BID #: WS 82-14

ADDENDUM NO. 2

METAL BUILDING

East County Repump Project
Okaloosa County Water and Sewer System
Okaloosa County, Florida

FILE	SEE LEFT
VERIFY SCALE	
BAR IS ONE INCH ON ORIGINAL DRAWING	
DATE	SEPT. 24, 2014
PROJ.	100100.70
DWG.	S1.0

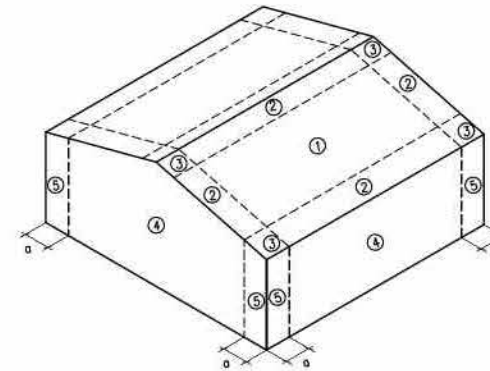
- 1) Structural Drawings:
 - a. **REPLACE** – Plan Drawings S1.0 General Notes in its entirety with the attached revised Drawing S1.0.
- 2) General Drawings:
 - a. **CLARIFICATION** – Plan drawing G1.1:

MECHANICAL PIPING PLAN

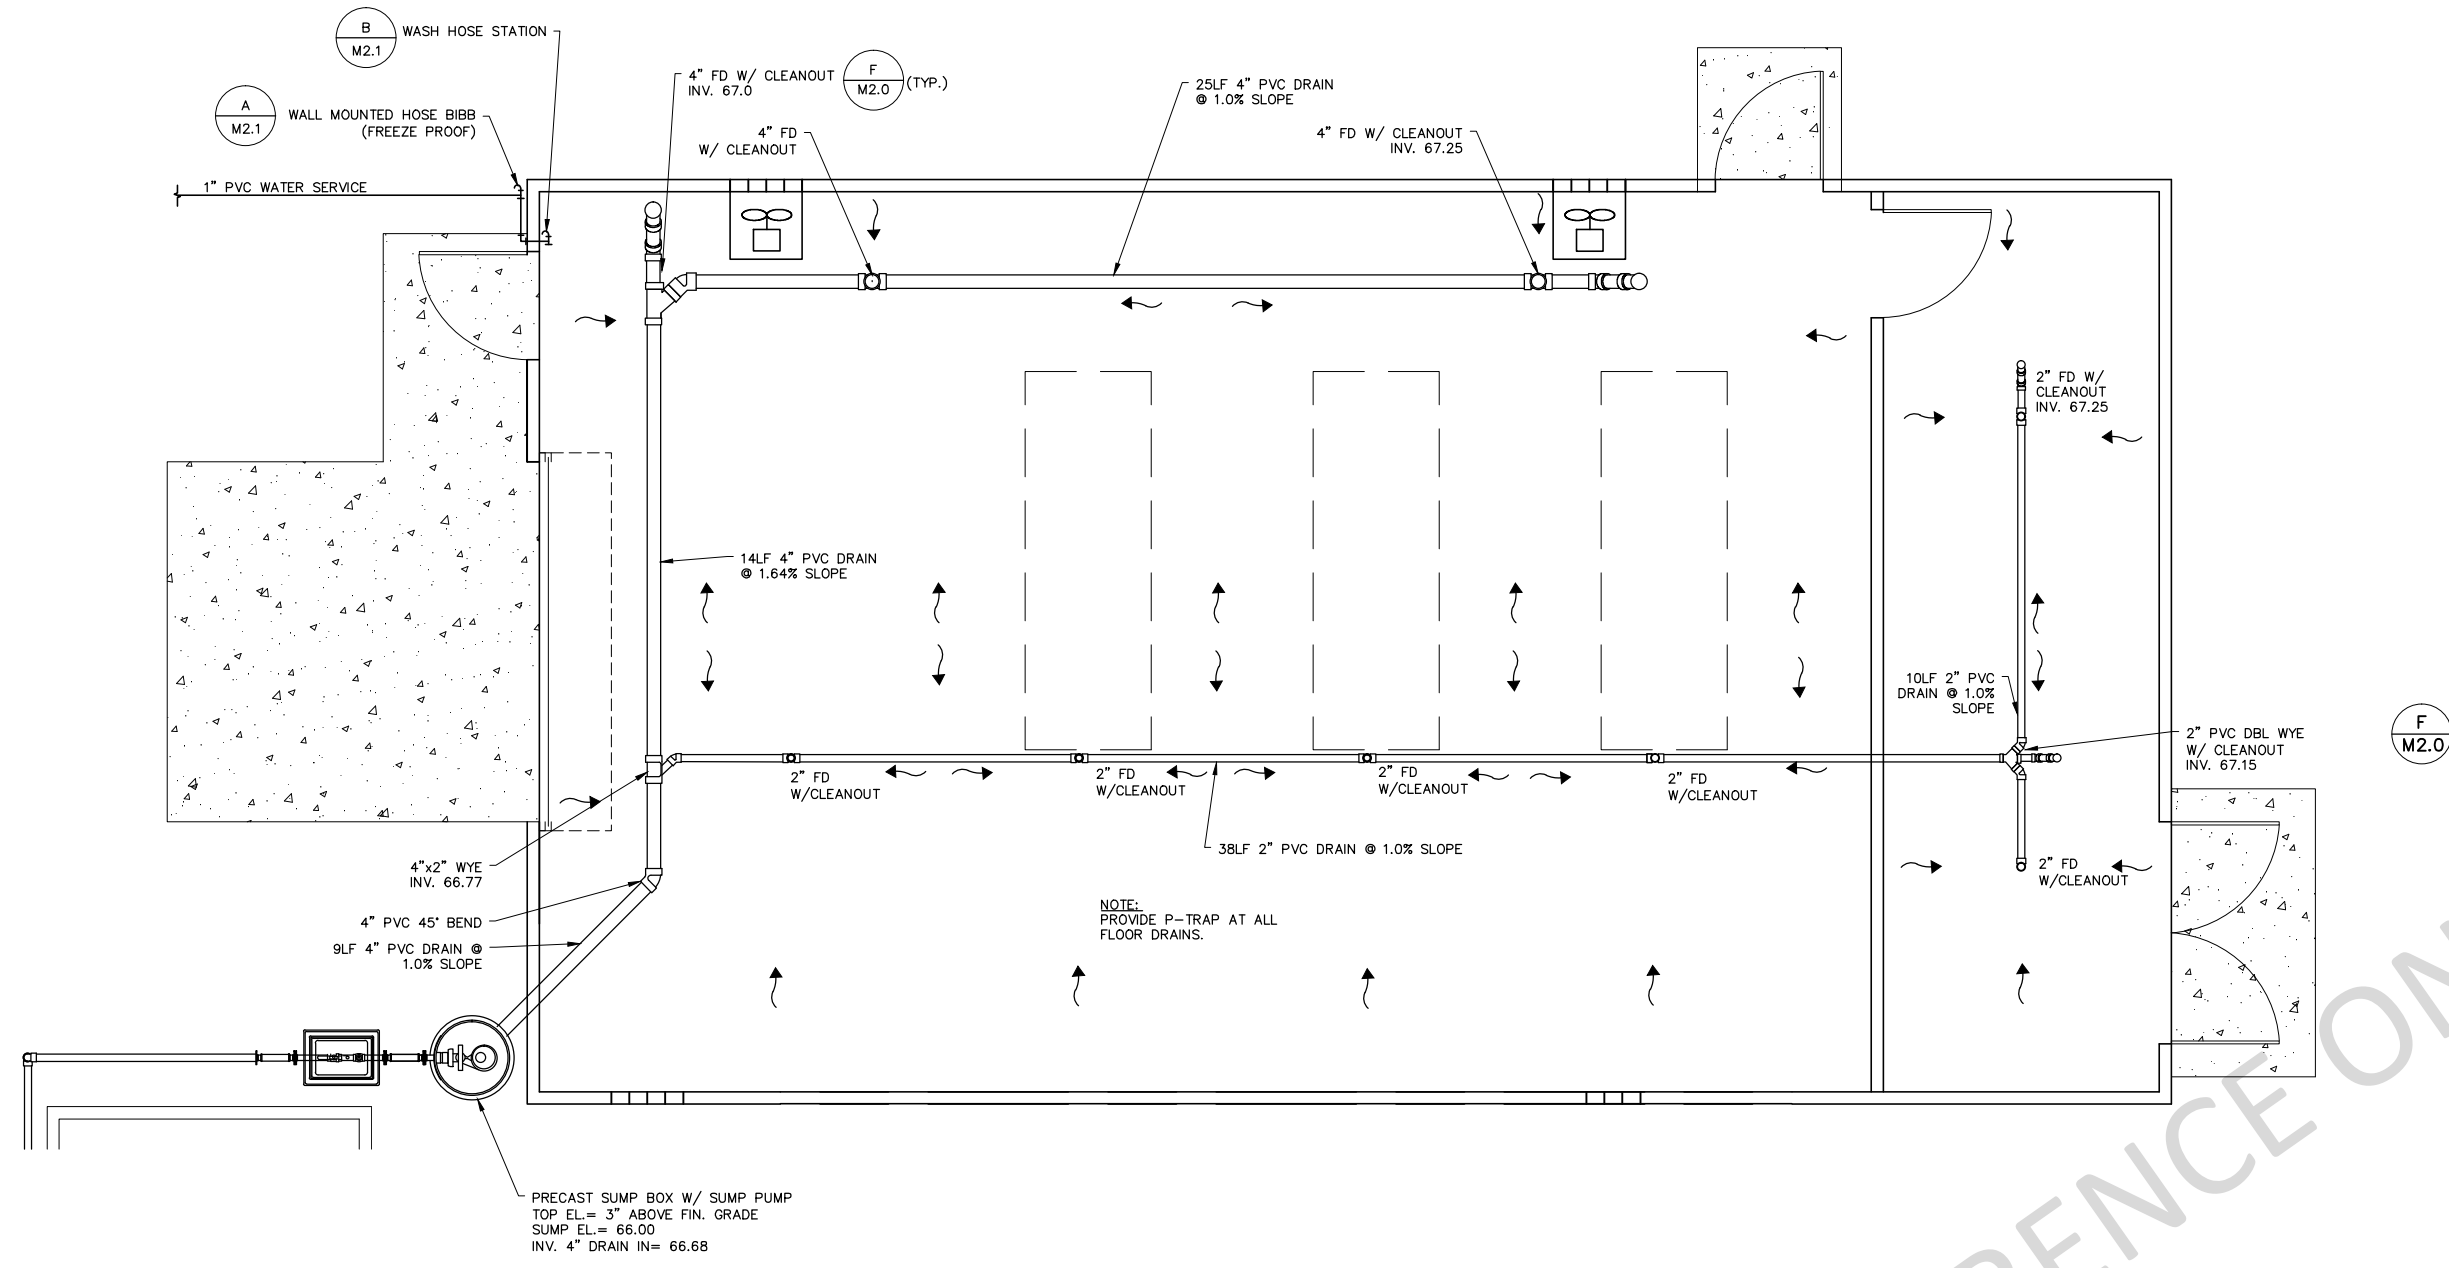
- i. General Note 2. The reference to the Contractor for site clearing activities pertains to the Site/Civil Contractor (Okaloosa County)
- 3) Mechanical Drawings:
 - a. **CLARIFICATION**- Plan Drawing M1.0- Concrete Pump Pad dimensional requirements.
 - b.
- 4) Structural Drawings:
 - a. **REPLACE** – Plan Drawings M1.2 Mechanical Piping Plan in its entirety with the attached revised Drawing M1.2
